Maule Aircraft Corporation

SERVICE LETTER #47

SUBJECT: New Flap Ratchet.

AIRCRAFT AFFECTED: MAULE Model M-5-210TC, Serial No's 9001C thru 9010C.

INSTALLATION INSTRUCTIONS

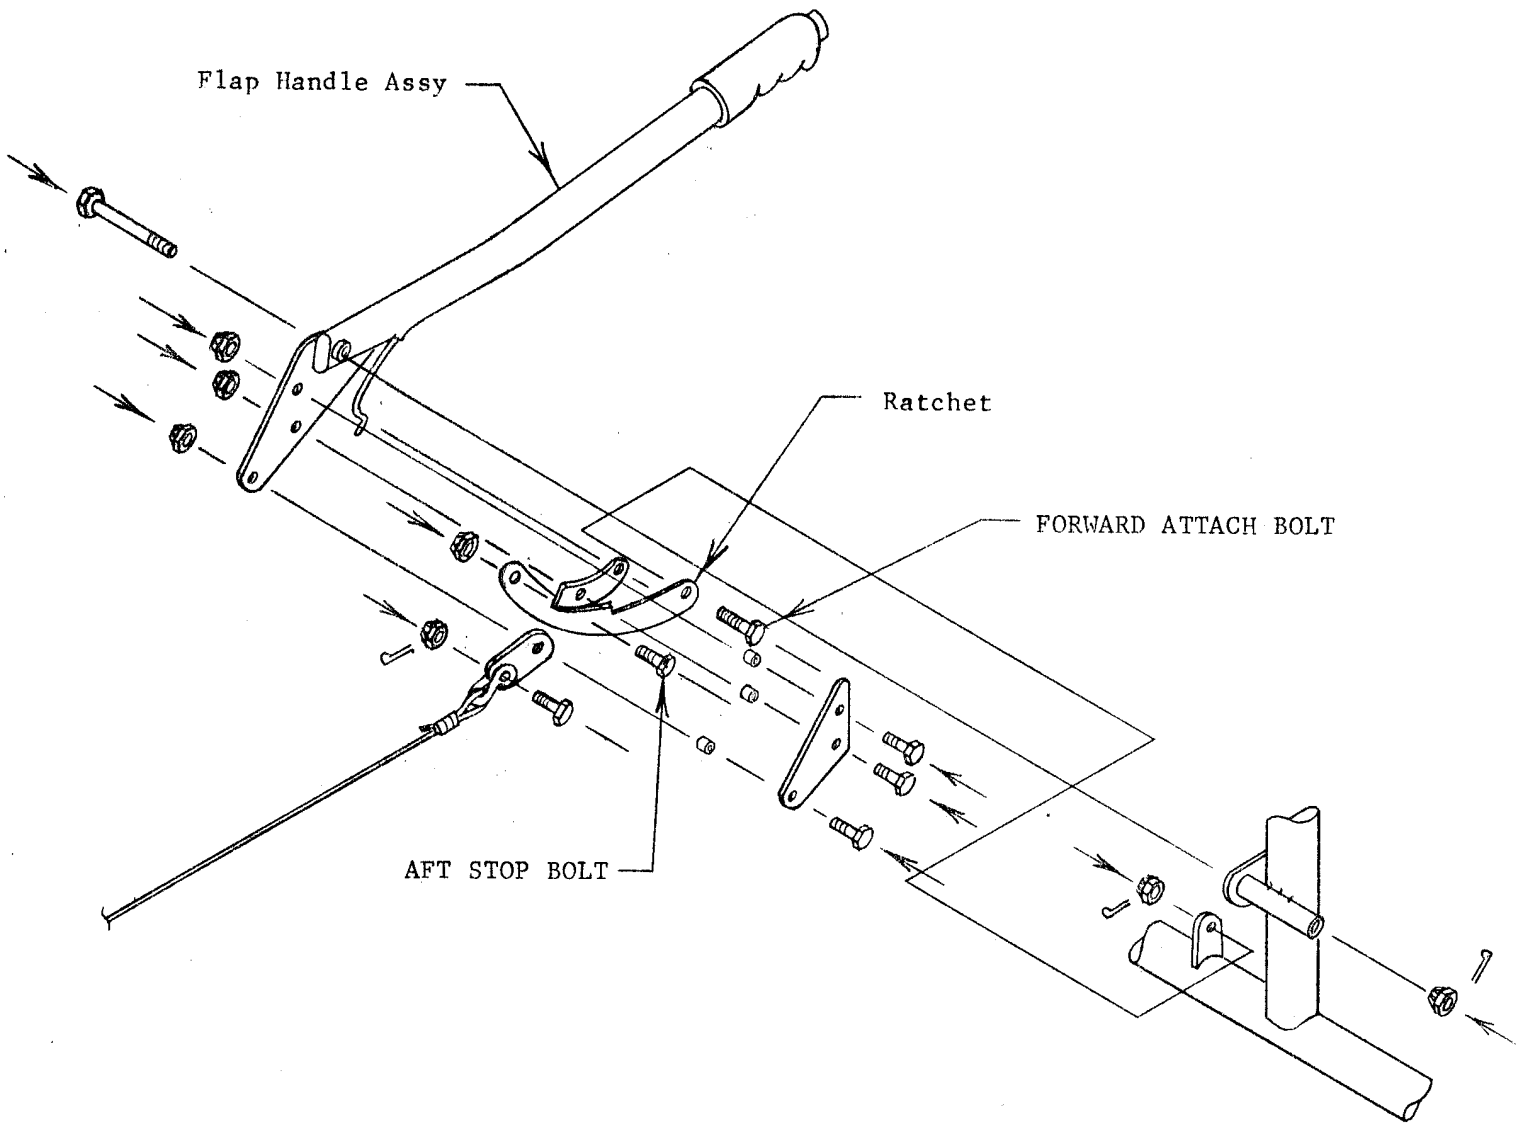
BACKGROUND: Many MAULE owners have requested increased flap travel for their airplanes. The new flap ratchet allows 5° - 8° more travel at each setting. There is also available an alternate lever which is bent upward. This allows more clearance under the lever for easier grasping. Either unit can be used separately.

- (1) Flap Ratchet p/n 3207B
- (1) Alternate Flap Lever Assembly p/n 3058F-28 (opt.)
- (1) Flap Handle Placard (20°-40°)
- (1) Installation Sketch

1. Remove left front seat.
2. Remove control cover (ref. Item 6, Group C-4 of Parts Catalog)
3. Remove old ratchet:
 - (a) Remove forward ratchet attach bolt and nut.

- (b) Remove aft stop bolt and nut.
 - (c) Slide ratchet forward thru plates of flap handle assembly.
4. Install new ratchet:
 - (a) Slide ratchet aft thru plates of flap handle assembly.

- (b) Install forward attach bolt and nut and secure with cotter pin.
 - (c) Install aft stop bolt and nut removed from old ratchet.
NOTE: 20°-40° ratchet has forward stop bolt and nut deleted.

- (d) Operational check flap system.
5. Reinstall control cover.
6. Reinstall left front seat.
7. Remove 15°-35° placard from flap handle and apply new placard.
